Notes from the DAC site visit held on Friday 15th of September 2021 at St Peter's, Poulshot.

This is a report of an inspection of the bells and fittings at St Peter's, Poulshot which was carried out on Friday 15th of September 2021 at the request of, and in company of, the Church Warden, Dankay Cleverly. The inspection was requested as the PCC are considering restoration of the church bells and improvements to tower access.

PLAN
At foundation beam level

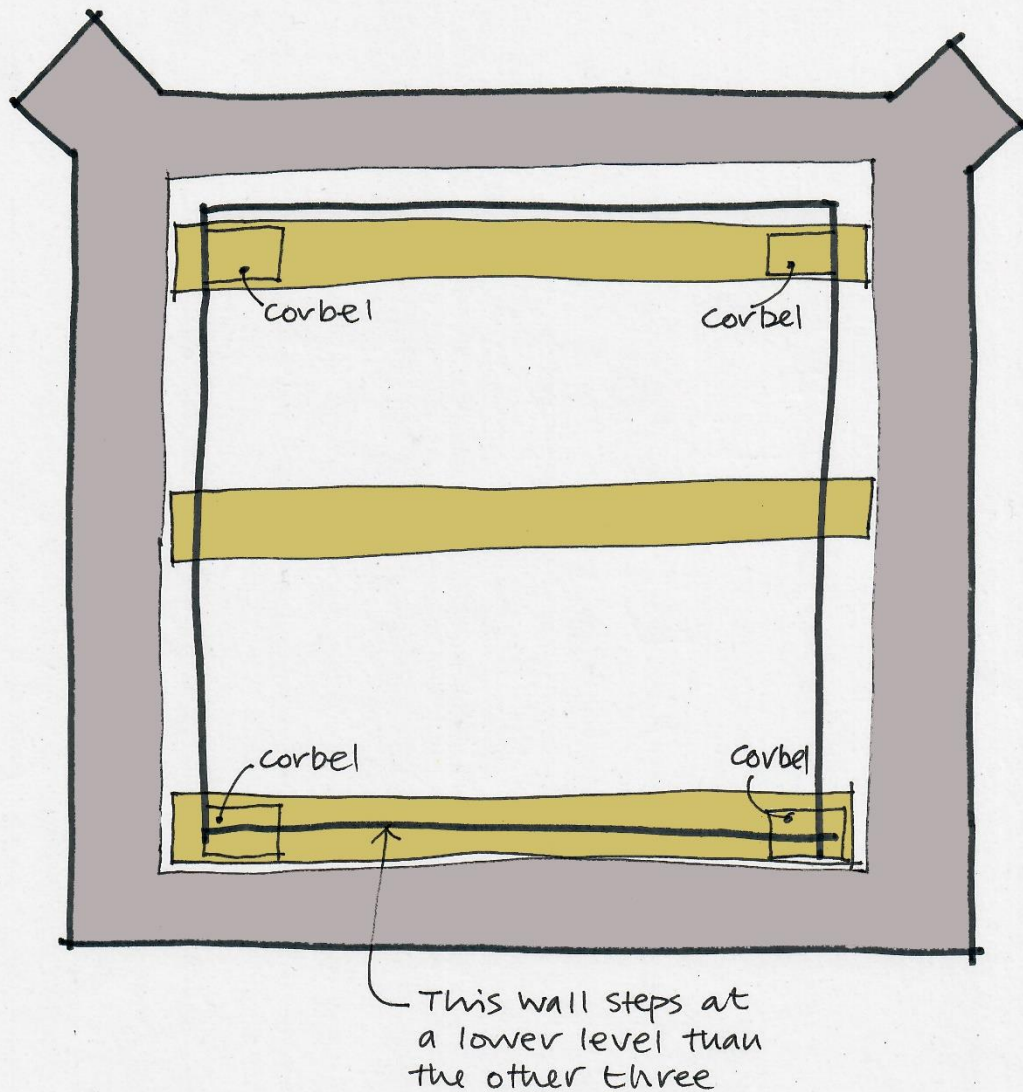
The Frame is set on three oak foundation beams running N/S across the tower, these beams appear to be in fair condition although they exhibit signs of worm and rot. As is to be expected the worst condition beams are those closest to the walls, and beam ends where built into walls. Fortunately, external beam ends bear on corbels in the corners of the tower. The central beam does not have corbels but is in fair condition although the worm damage at some points has caused the surface of the timber to become detached. The foundation beams sit on a ledge formed by a reduction in the thickness of the tower walls. Some of the floor boards above these beams are showing signs of advanced decay.

PLAN
At frame Level

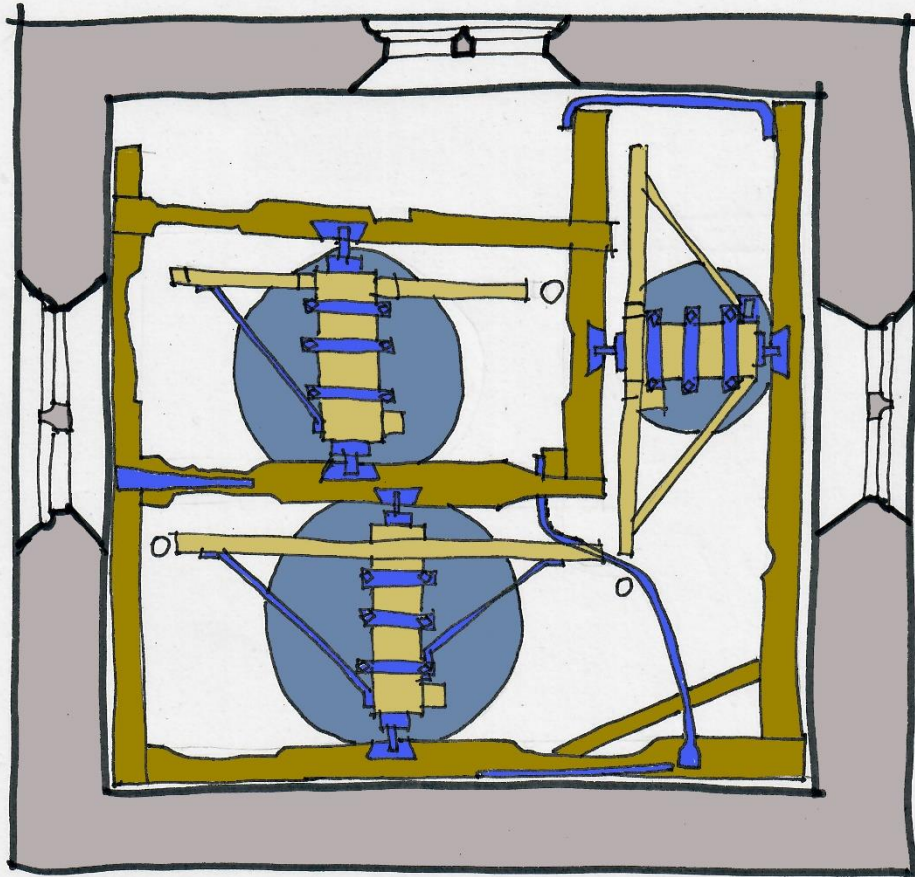
The current Frame was probably put into its current form in 1606 and is of the long framehead type with curved braces and kingposts. There is one jackbrace. The current layout was probably fabricated from a previous frame which was modified to accommodate the two 1606 bells. The south side of the treble frame, and the west side of the tenor frame terminate before reaching the outer frame and repairs and additional braces have been inserted, at a later date, to overcome likely frame movement caused by the unusual frame in this position. This space also accommodates the access stairs.
